Addendum No. 2
March 13, 2025

Project: Brandon Valley Middle School Addition
Brandon, South Dakota
Project #3090

Architect: Architecture Incorporated

9.30-B

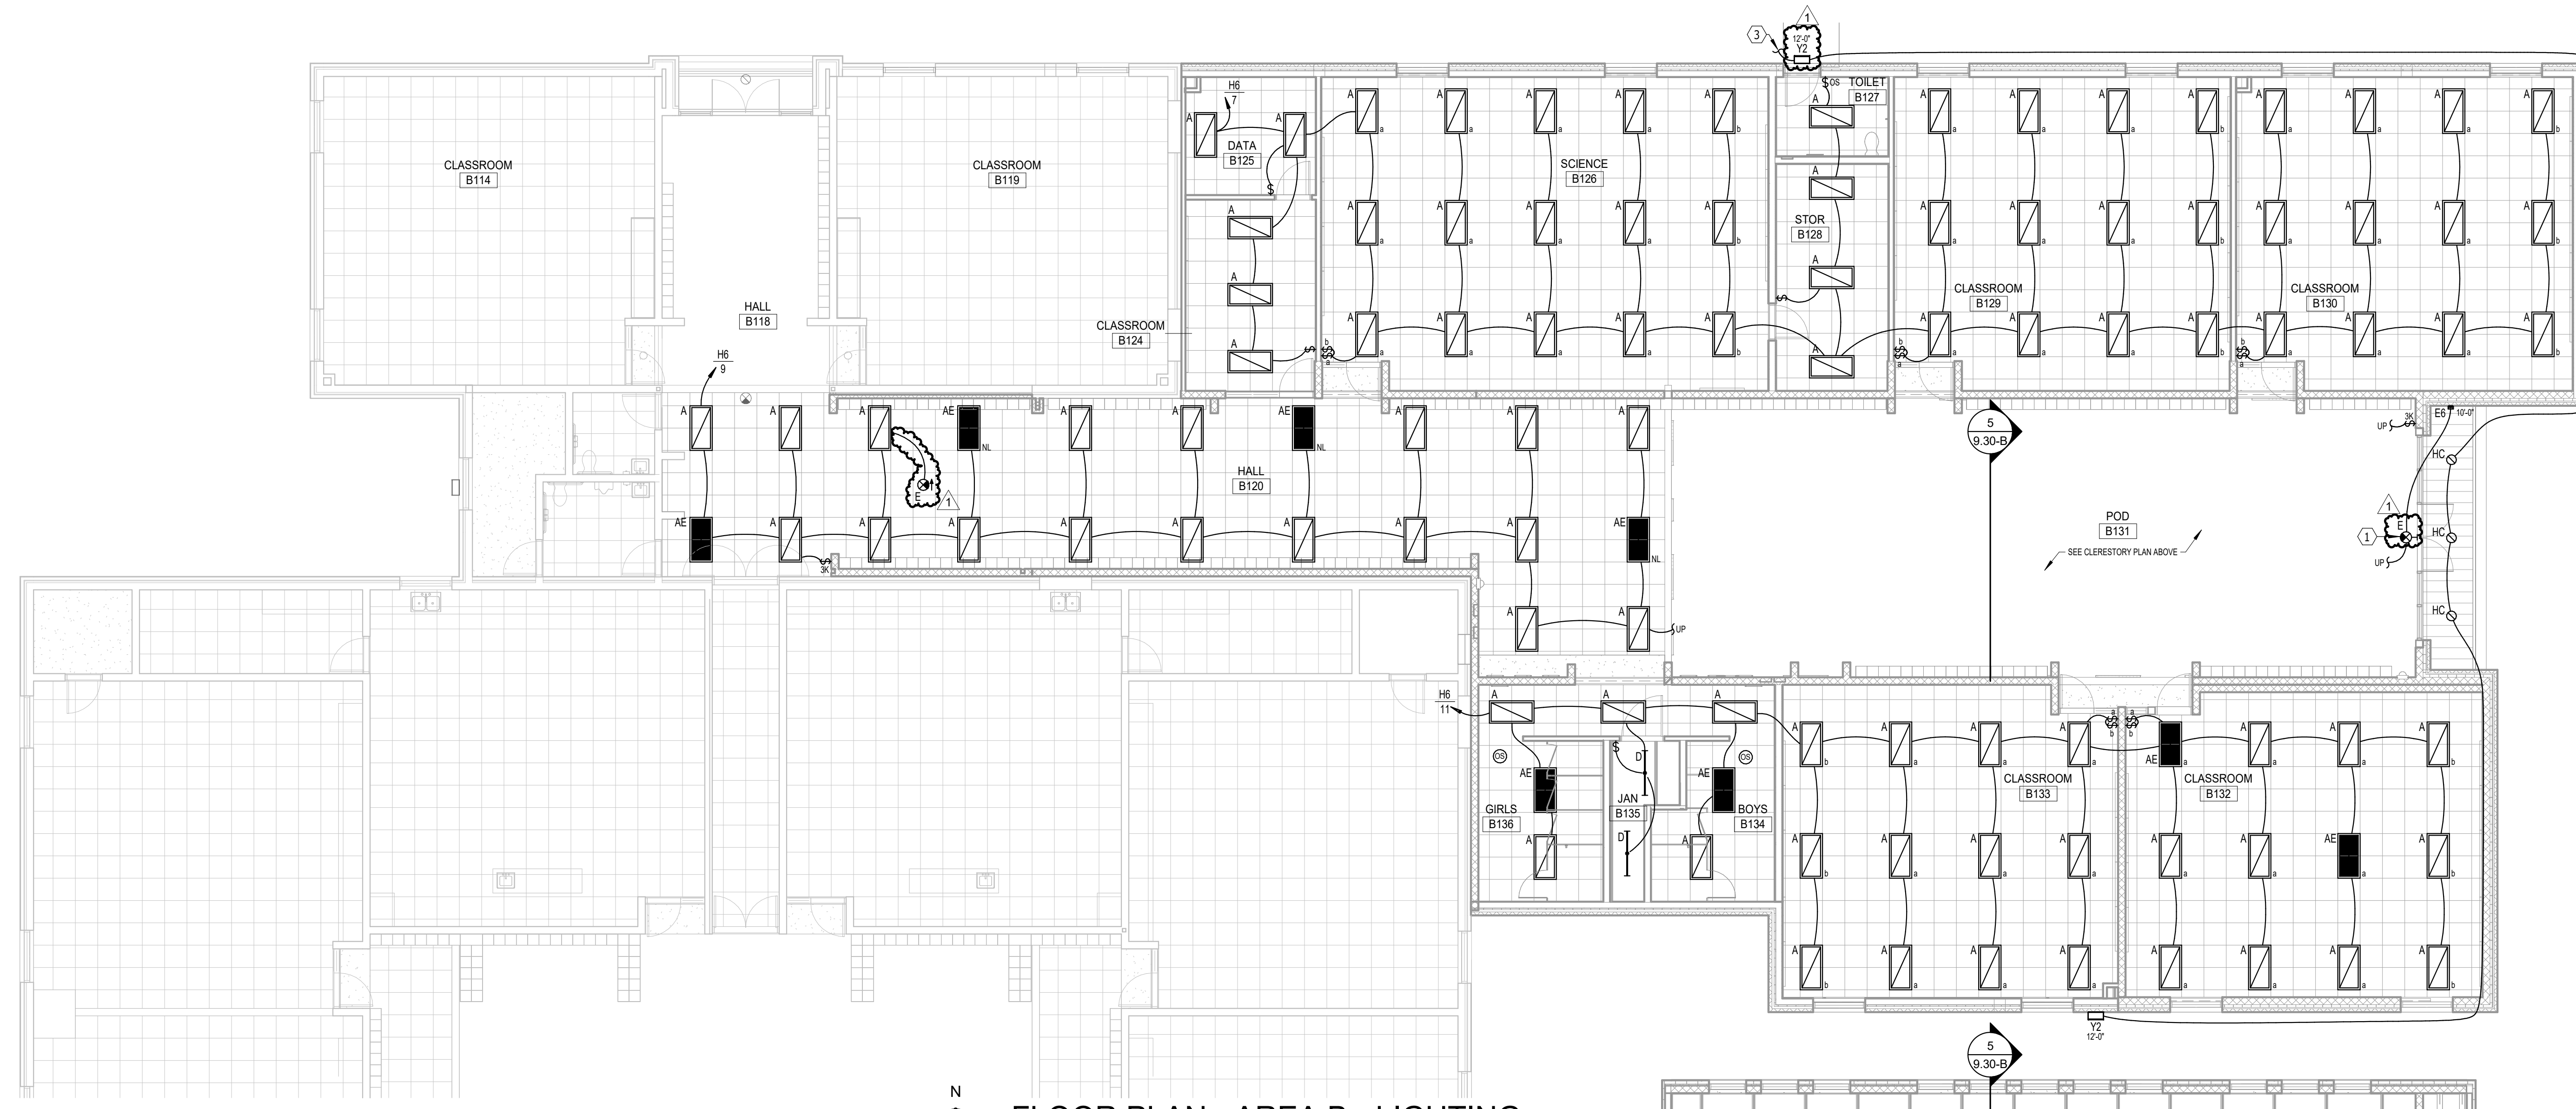
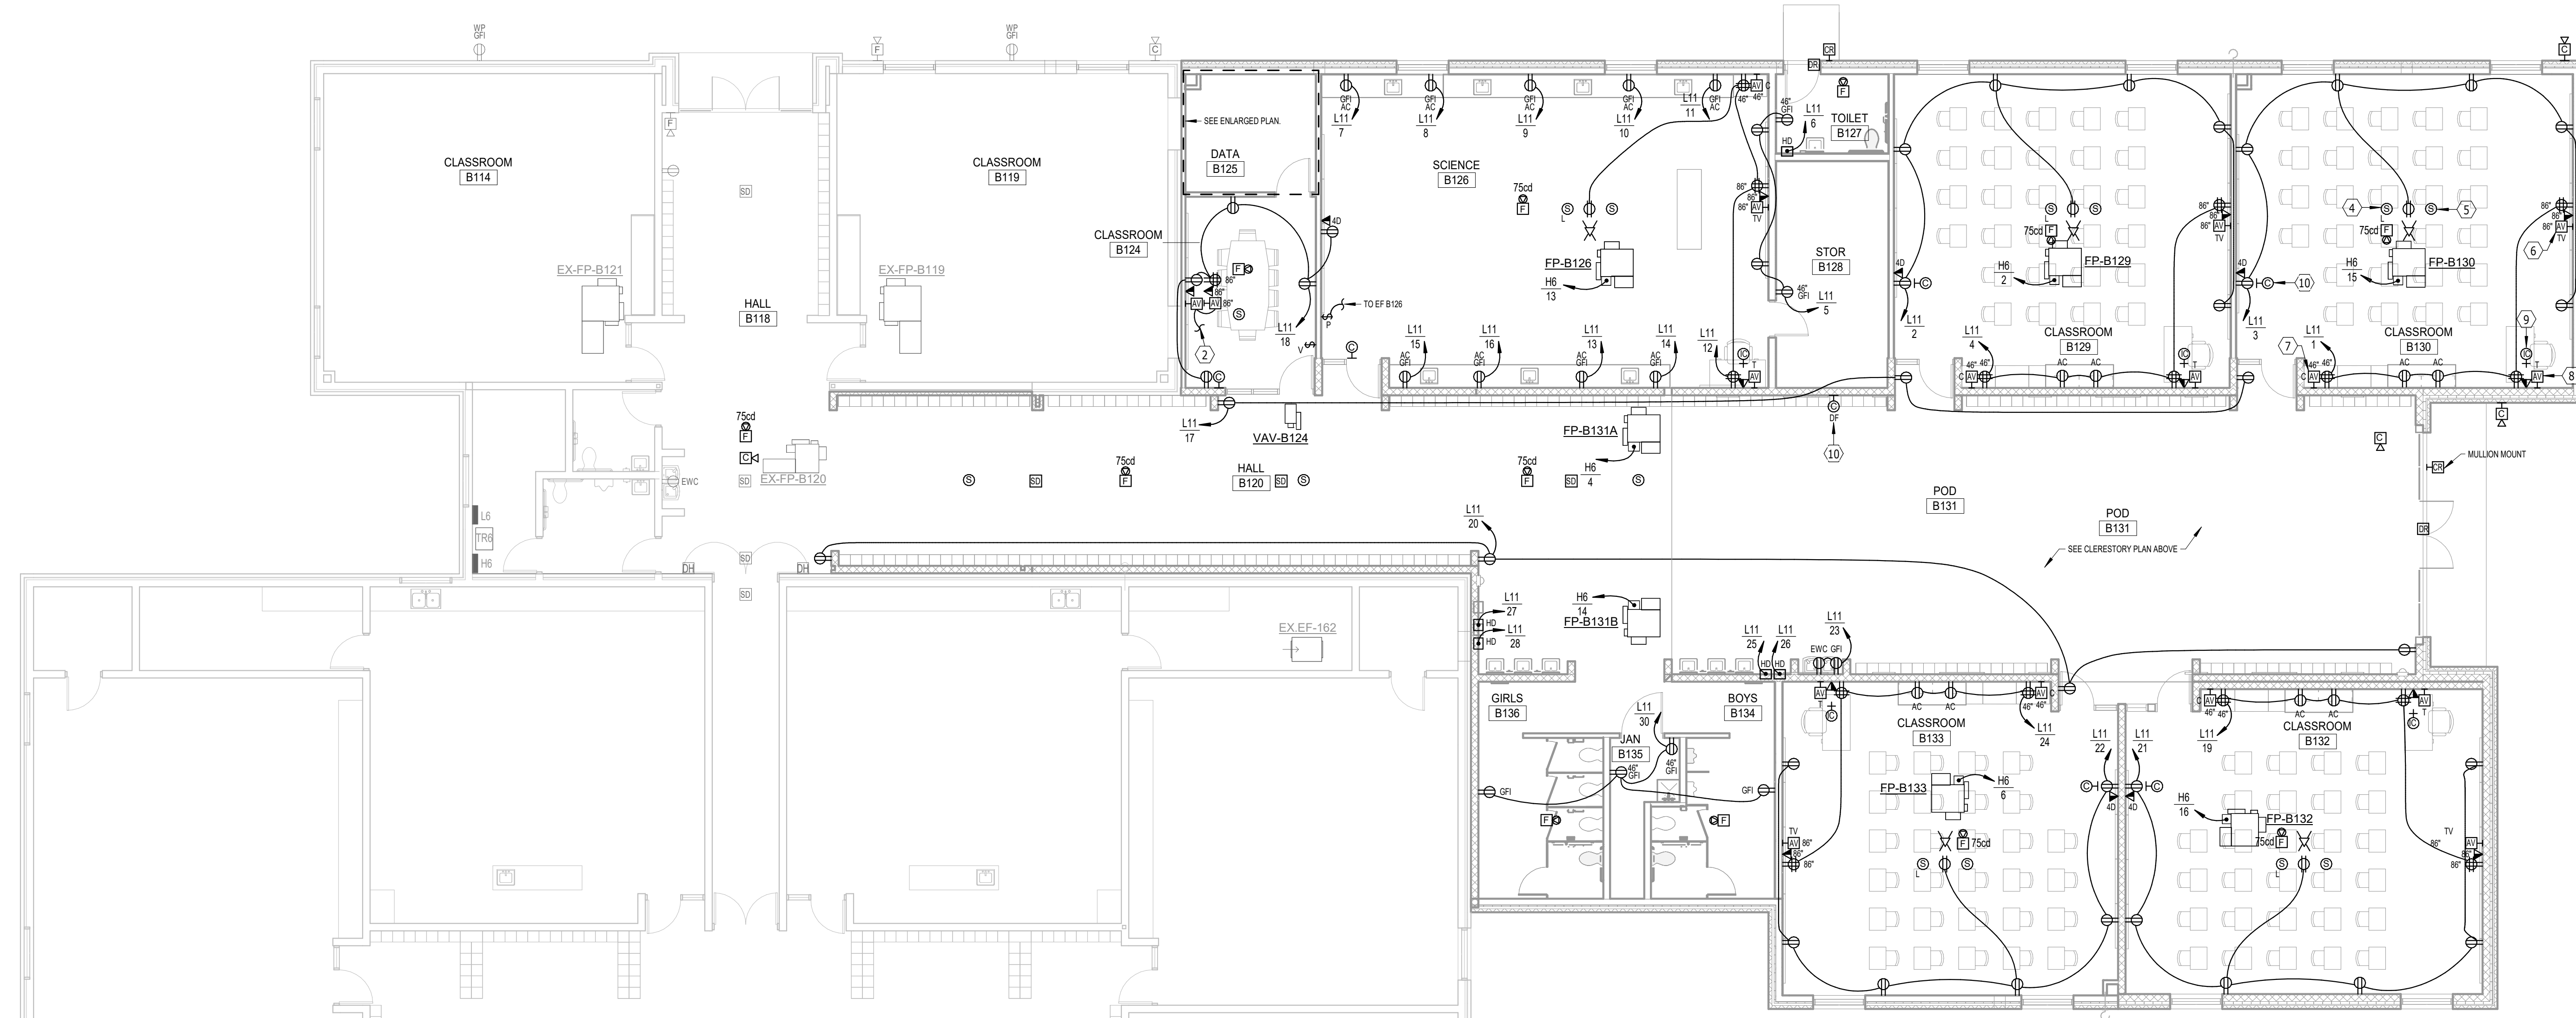
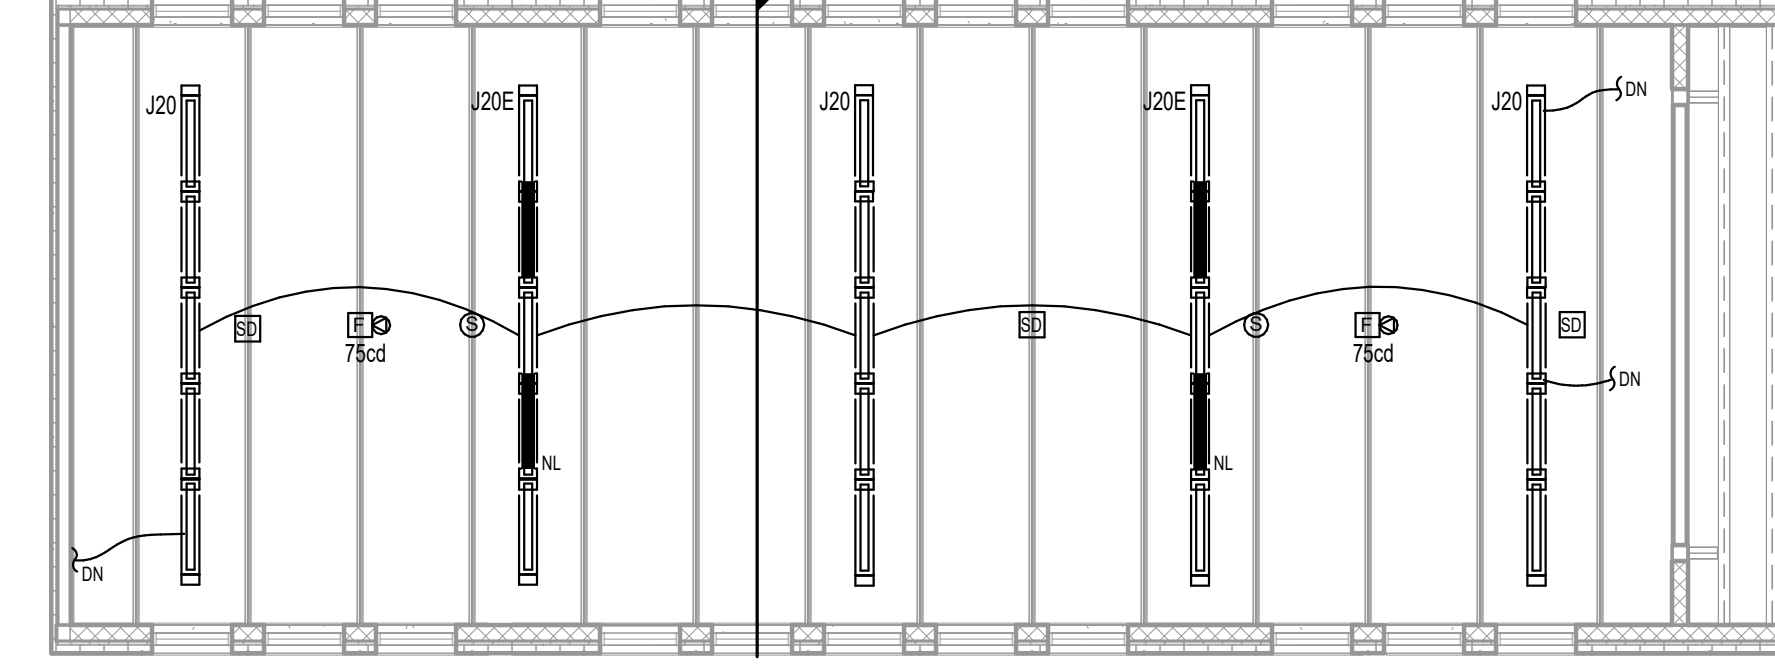
- 5) SHEET 9.30-B – FLOOR PLAN – AREA B – ELECTRICAL
 - a) Reference *revised* Sheet 9.30-B, revision dated 3-13-2025, attached to the end of this addendum for following modifications:
 - i) Change Exit light in POD B131 to type E.
 - ii) Add Type E exit light on west end of Hall B120.
 - iii) Change (2) Type Y3 fixtures to Type Y2 on building exterior.
